To: CGG Algoa Stakeholder Engagement Team
SLR Consulting (South Africa) (Pty) Ltd

From: The Green Connection and Natural Justice

31 May 2023

COMMENTS ON THE BASIC ASSESSMENT REPORT FOR PROPOSED SPECULATIVE 3D SEISMIC SURVEY IN THE ALGOA, AND OUTENIQUA BASINS OFF THE SOUTHEAST COAST, SOUTH AFRICA

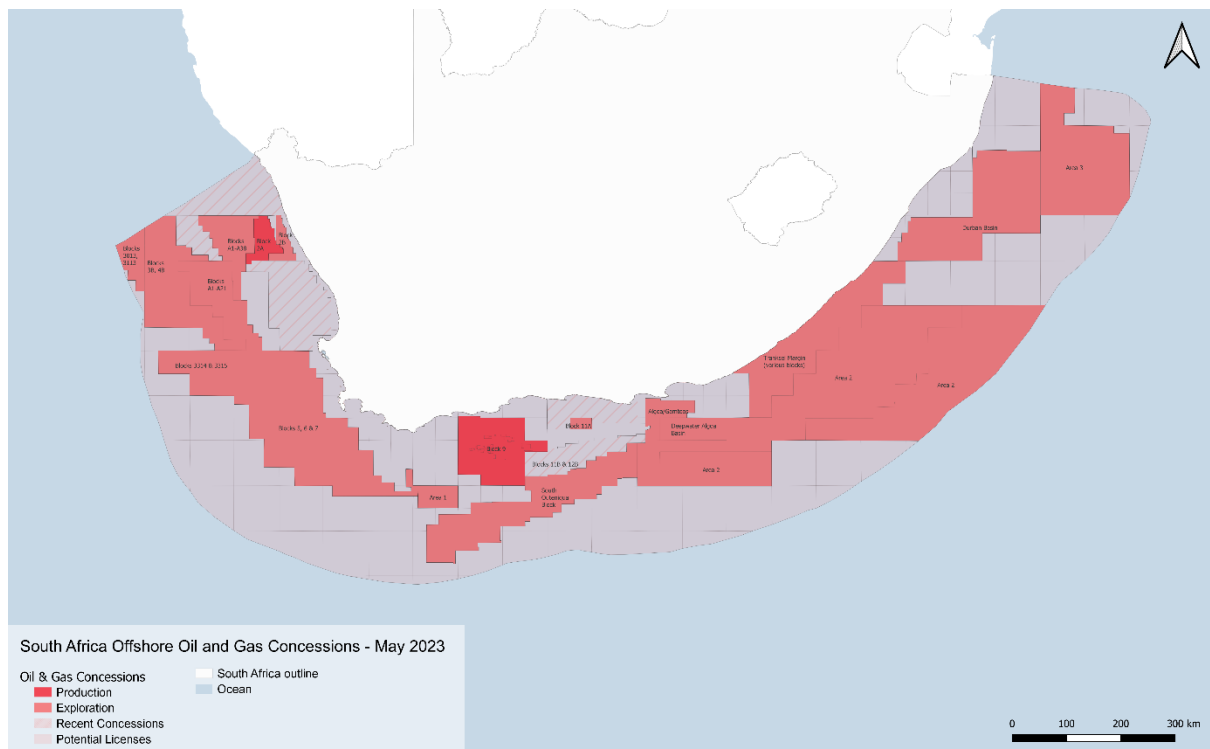
50.6. The BAR appears to recognize the concern for the potential for cumulative impacts stemming from increased background anthropogenic noise levels which are likely to be ongoing and widespread.⁸⁸ However, the BAR fails to assess the cumulative impacts of other seismic testing and exploration activities on these species. The BAR states that, “Should other speculative or proprietary seismic survey campaigns be undertaken concurrently with CGG’s proposed survey campaigns be undertaken concurrently with CGG’s proposed survey off the Southeast Coast, cumulative impacts may be likely, and there would need to be alignment in planning of such concurrent operations in order to avoid cumulative impacts”.⁸⁹ In addition, there are multiple other publicly announced oil and gas exploration activities set to commence off the east and south-east coasts of South Africa which overlap with the CGG’s proposed seismic survey. See below references to the above:
